## **10 CFR72 Application of CASTOR® geo69 Dry Storage System**

GNS Gesellschaft für Nuklear-Service mbH

Technical Meeting

**Request for Supplemental Information with Observations  
Model No. No. CASTOR® geo69 Storage Cask  
Docket No. 72-1052**

## Alternative Concept of Safety Evaluations - DSS

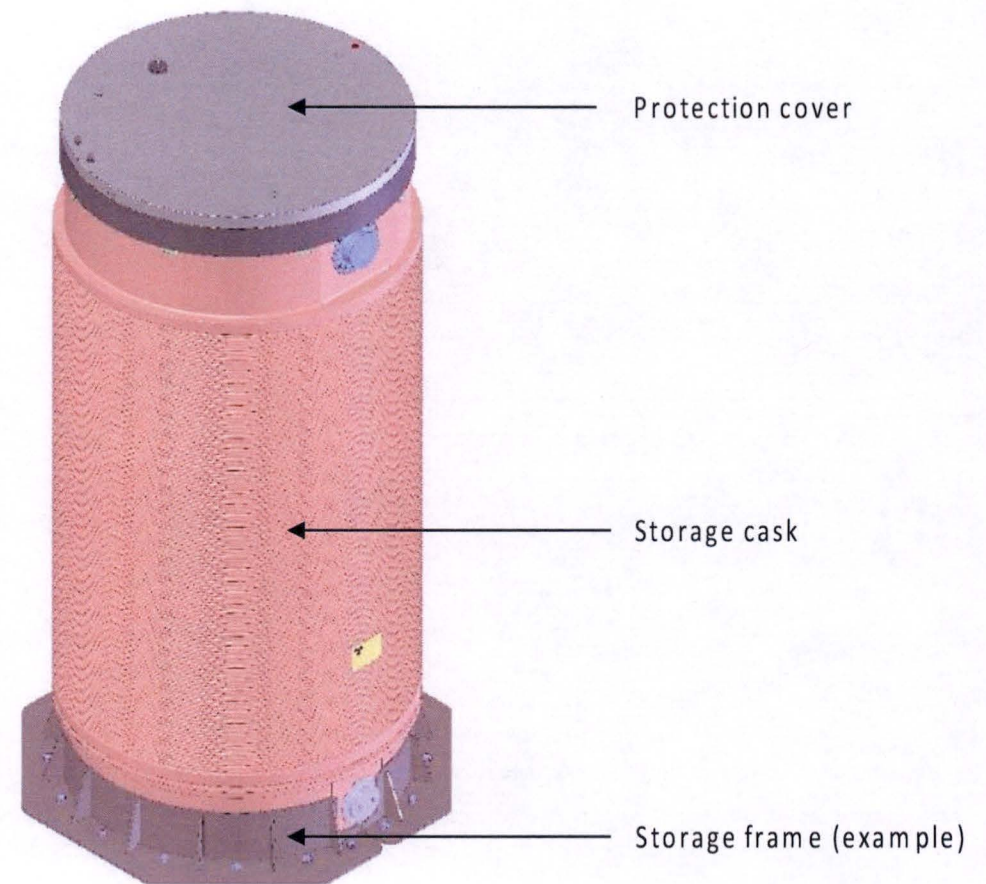
- If current evaluation concept is not accepted by NRC ...
- Alternative approach by GNS:

- Free-field storage of DSS:

DSS extended by a storage frame anchored on reinforced concrete foundation

⇒ Fully comprehensive safety evaluations ...

- according to NUREG-2215, Section 3.5.2.4
      - Normal
      - off-normal
      - accident conditions
      - natural phenomena

⇒ ... without taking credit of any installations of the storage facility (building, pad, etc.) are to be performed.
